FINAL PLAT

R.T.I. ADDITION

Re: S/D 96-54 - R.T.I. ADDITION (Final Plat)

STAFF REPORT
(Final Plat Approved 8/22/96)

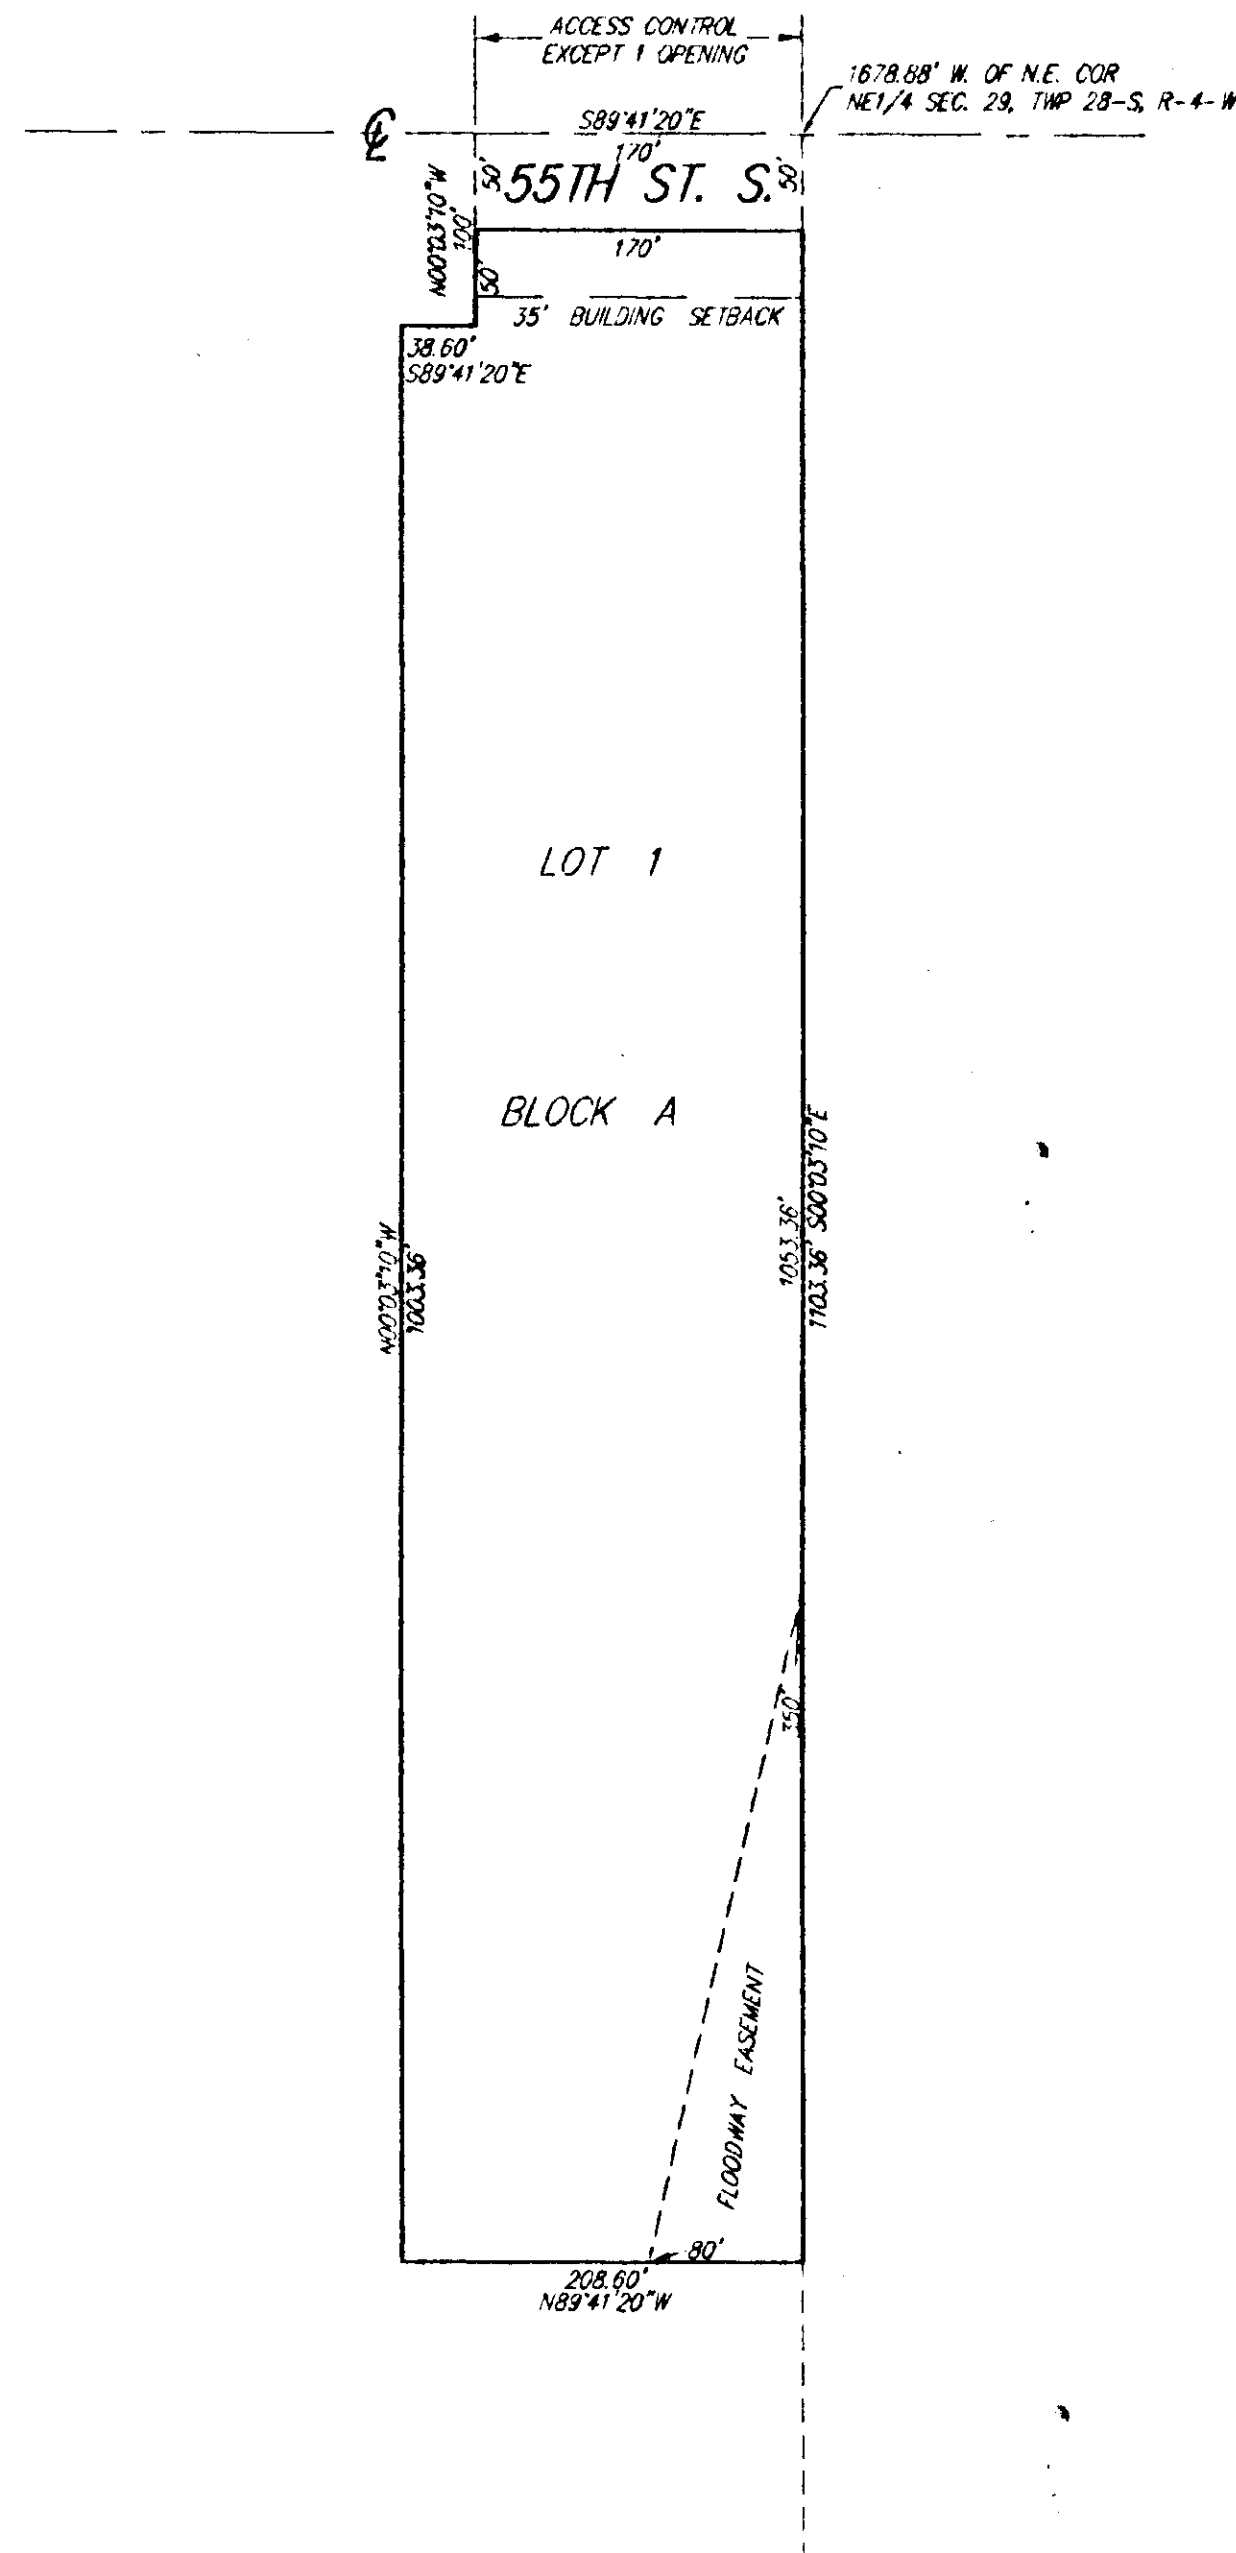
- B. The applicant shall guarantee any drainage improvements required by the platting of this property.
- C. Based on the existence of a floodway on this site, County Engineering is requiring a minimum building elevation of 1,343'. Such elevation shall be noted both in the plat's text and on the face of the plat. Also, both an on-site and off-site benchmark shall be shown.

- D. In regard to the floodway, County Engineering indicated the involved area of this lot should be shown as a Floodway Reserve.
- E. It should be noted that for non-residential lots, the lot depth to width standard of 2 1/2:1 does not apply.

- H. The applicant's engineer is advised that the Register of Deeds is requiring the name(s) of the notary public, who acknowledges the signatures on this plat, to be printed beneath the notary's signature.
